# SERVICE BULLETIN RI

February 27, 1998

### SAFETY RECALL CODE 0808 -TURN SIGNAL FLASHER

B-014

Figure 1. Turn Signal Wires

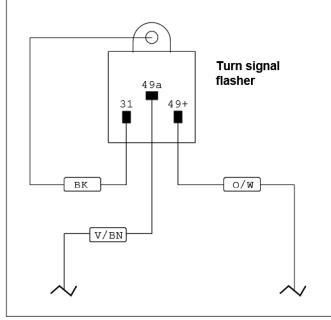
This condition will be remedied by replacing the turn signal flasher in all potentially affected vehicles.

- Remove seat, tail section and frame heat shield (if equipped). Refer to the appropriate Service Manual for specific instructions if necessary.
  - a. S1/S1W models, Part No. 99490-98Y (information applies to all model years).
  - M2 models, Part No. 99491-98Y.
  - c. S3/S3T models, Part No. 99489-98Y.
- Remove 1/4-20 allen head screw which secures turn signal flasher clamp to frame.
- Detach wiring from turn signal flasher. Discard turn signal flasher and clamp.
- See Figure 1. Attach wiring to new turn signal flasher.
  Terminal numbers are marked on bottom of flasher.
  - a. Connect violet/brown wire to terminal 49a.
  - b. Connect orange/white wire to 49+.
  - c. Connect black ground wire to 31.
